Change order CO-002: add bedroom window W8

Garage Suite, 123 Example Street NW

CHANGE ORDER	**CO-002**
DRAFTED	Wed Oct 14, 2026, 2:14 PM
CONTRACT	Aug 21, 2026 (Q-0146 + A1)
STATUS	Approved Thu Oct 15, 9:05 AM

SK-CO-002 · Level 2 plan (from A-102 Rev 0), marked up for change order CO-002

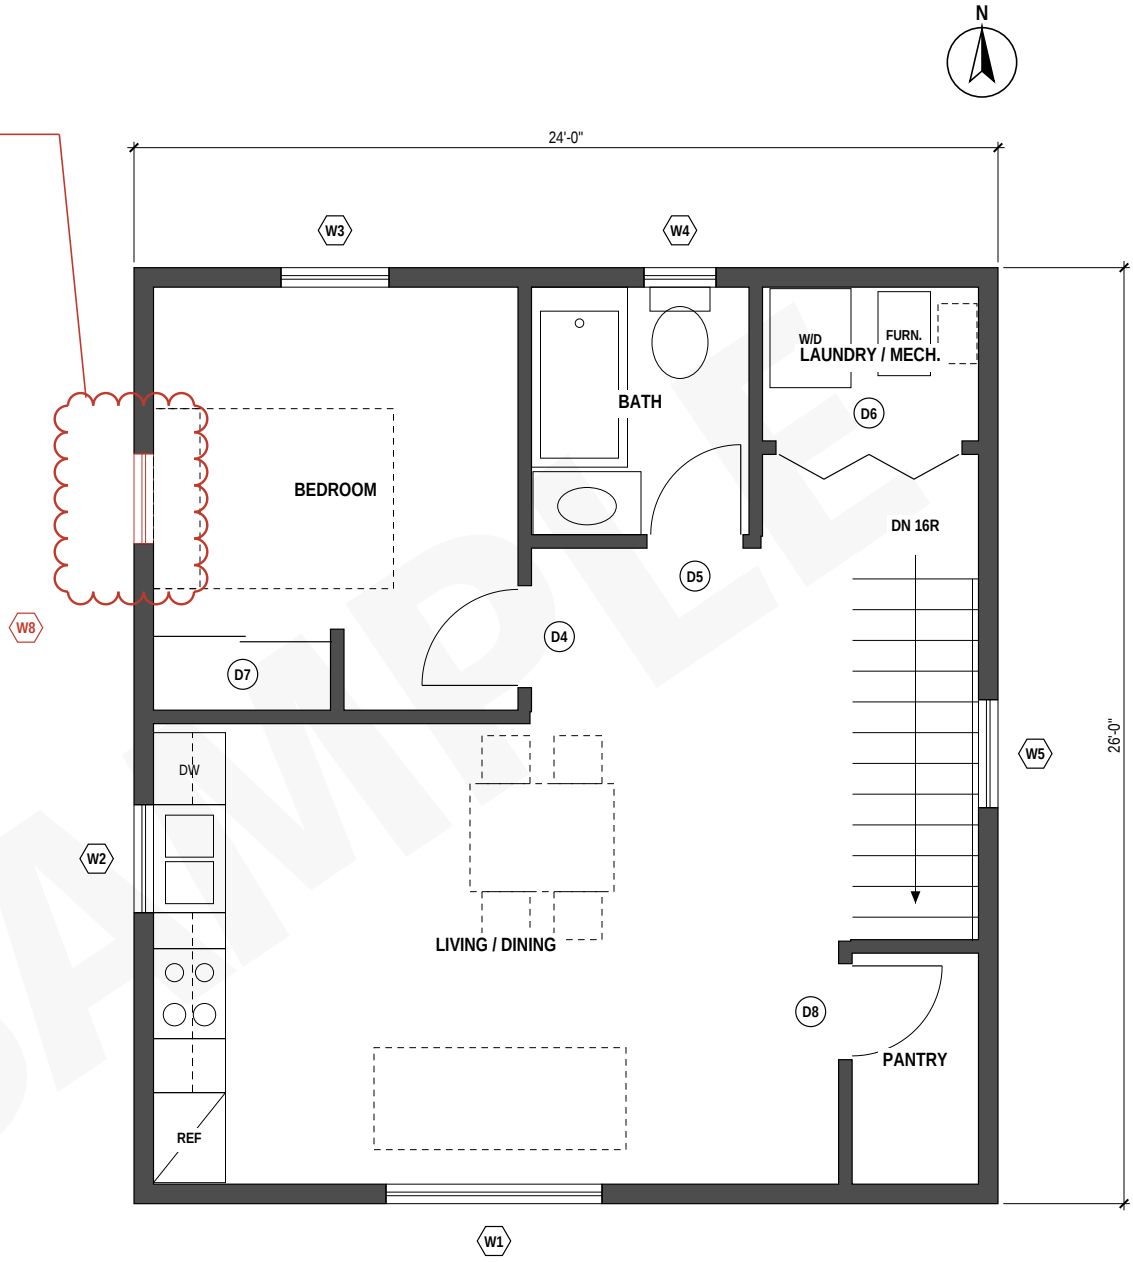
Add window W8 in the level 2 bedroom, west wall: 30" x 48" casement, triple-glazed vinyl, to match W3.

Add W8: 30" x 48" casement, triple-glazed vinyl, match W3. Centre 6'-5" from the north face of the building. R.O. 31" x 49", 2-2x8 header with 2" XPS. Sill 24" A.F.F. Frame Oct 15, wall open.

- Frame a 31" x 49" rough opening in the west wall on Thu Oct 15, while the wall is still open: kings, jacks, 2-2x8 header with 2" XPS, sill and cripples.
- Supply and install W8 with a sill pan and jamb and head flashing lapped to the weather barrier.
- Adjust the siding and trim around the window.
- Drywall return, casing and paint inside.

Condition
The west wall is 4'-0" (1.22 m) from the property line. Before the window is ordered, the designer confirms that the added opening meets the spatial separation requirements (NBC(AE) 9.10.15). If it does not, we infill the opening at no cost and this change order is void.
